**Written submission from
Frank Greening**

**Bruce Power Inc.
Bruce Nuclear Generating Stations A and B**

**Application to amend the power reactor
operating licence for the Bruce Nuclear
Generating Stations (NGS) A and B**

April 2023

Figure 1a: Pressure Tube B3U11

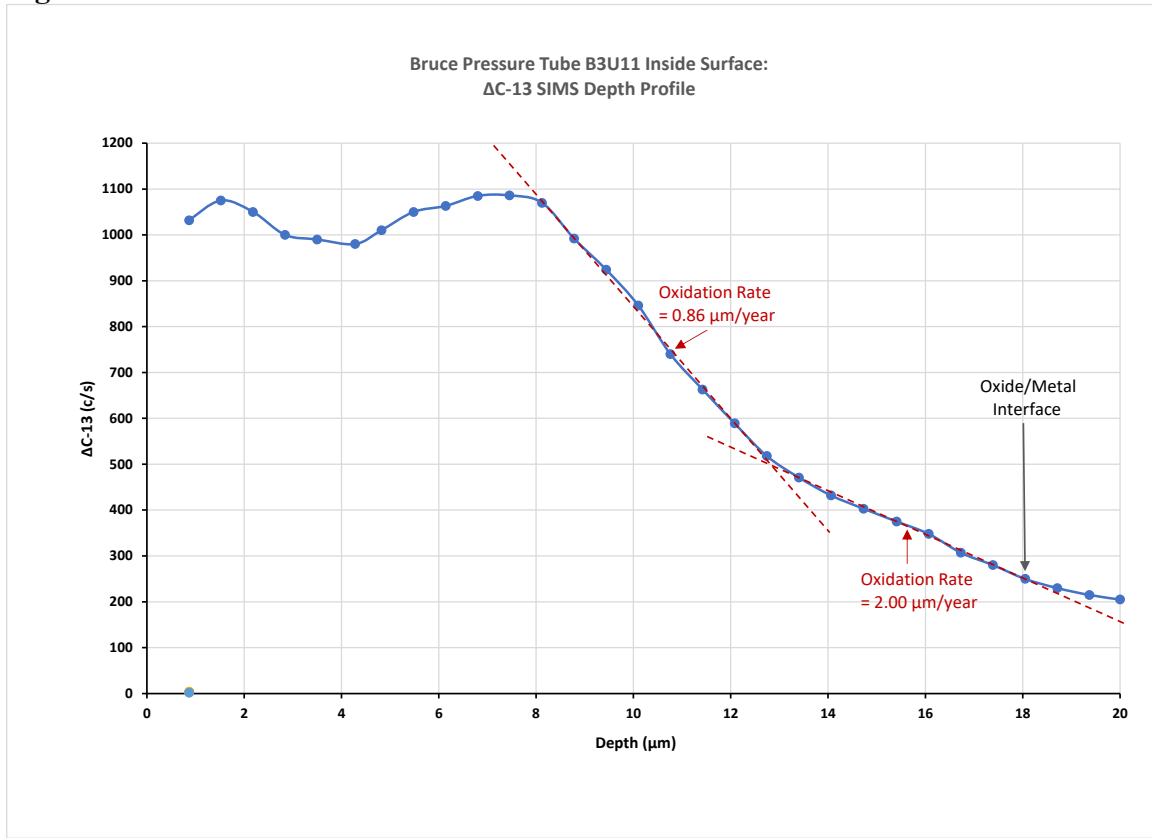
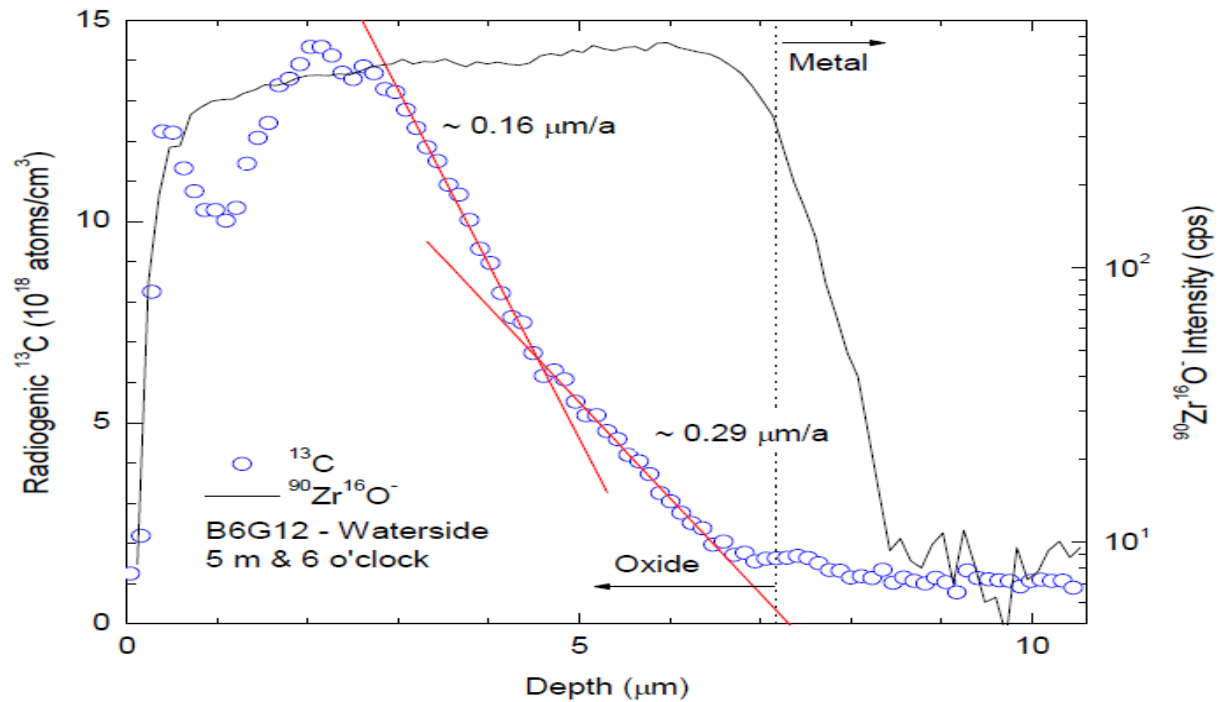
The C-13 plots in Figures 1a and 1b exhibit the following features for the B3U11 and the B6G12 pressure tubes:

- (i) The B3U11 tube's ID oxide is 20 μm thick, compared to only a 7 μm thick oxide for the B6G12 tube
- (ii) An approximate doubling of the pressure tubes oxidation rate is observed after about 13 μm of growth for the B3U11 tube, compared to a similar doubling for the B6G12 tube, but after only about 5 μm of growth

These observations show that there is a great deal of variability in the oxidation rate of the inside surfaces of Bruce pressure tubes. However, these data also show that there is a tendency for the oxidation rate to increase at higher hot hours of exposure, and this occurs *regardless of the initial rate of oxide growth*. This acceleration in the rate of oxidation of pressure tubes is very significant because it has implications for the associated rate of H/D pickup by these tubes. This is because zirconium alloy pressure tubes pick up deuterium during zirconium corrosion in D₂O through the following two-step processes:

Figure 2.9: The fracture toughness of cold worked Zr-2.5Nb pressure tubes at 240-300 °C after service in a CANDU reactor showing large variability

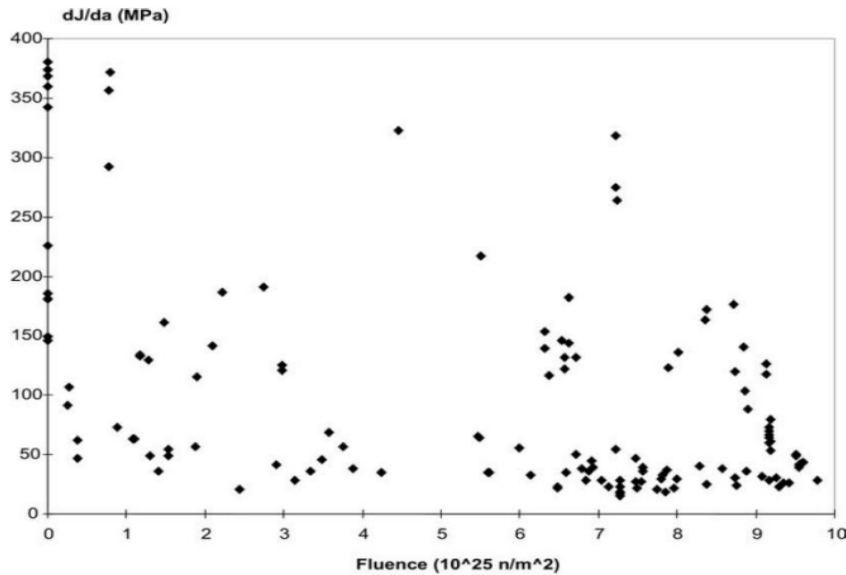
An issue that further complicates the validation of fracture toughness models is the fact that the fracture toughness of a pressure tube depends on many factors, including the [Heq], temperature, neutron fluence, trace impurities, etc., of the tube in question. This leads to a large variability in measured values of fracture toughness parameters such as a pressure tube's crack growth resistance, dJ/da , as shown in the Figure below:

This extreme variability in a tube's fracture toughness – a variability that is also seen in many other pressure tube properties such as H/D pickup rates – means that predictive models themselves are inherently uncertain and can only offer upper bounds, for H/D pickups, or lower bounds, for fracture toughness parameters.

Figure 1A: Plot of H/D Percent Pickup vs. Deuterium Pickup in ppm

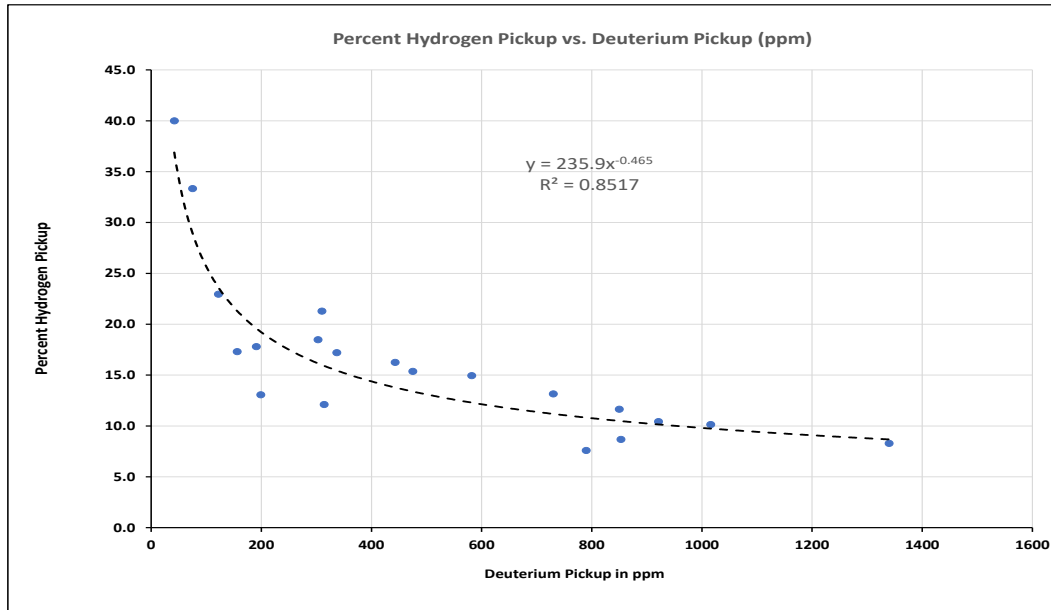
Also of interest in the data presented in Table 1A is the variation in the percent hydrogen (protium) pickup compared to the deuterium pickup at the same location, as plotted in Figure 1A. This plot shows that the percent of protium picked up by a tube, expressed as $100 \times [H]/[D]$ vs. $[D]$, is *inversely* proportional to $[D]$. Thus, when $[D]$ is low, the percent of protium picked up is high – as high as 40%. But when $[D]$ is high the percent of protium picked up is as low as 8%.

This behavior indicates that H and D most probably enter pressure tubes by at least two different mechanisms which most likely occur over different timelines. We know for a fact that, as installed, each pressure tube contains an initial amount of H (protium), usually in the range 5 to 15 ppm, and essentially no deuterium. Then, with increasing years of service, deuterium enters a pressure tube at an unpredictable rate that depends on each tube’s physico-chemical makeup.
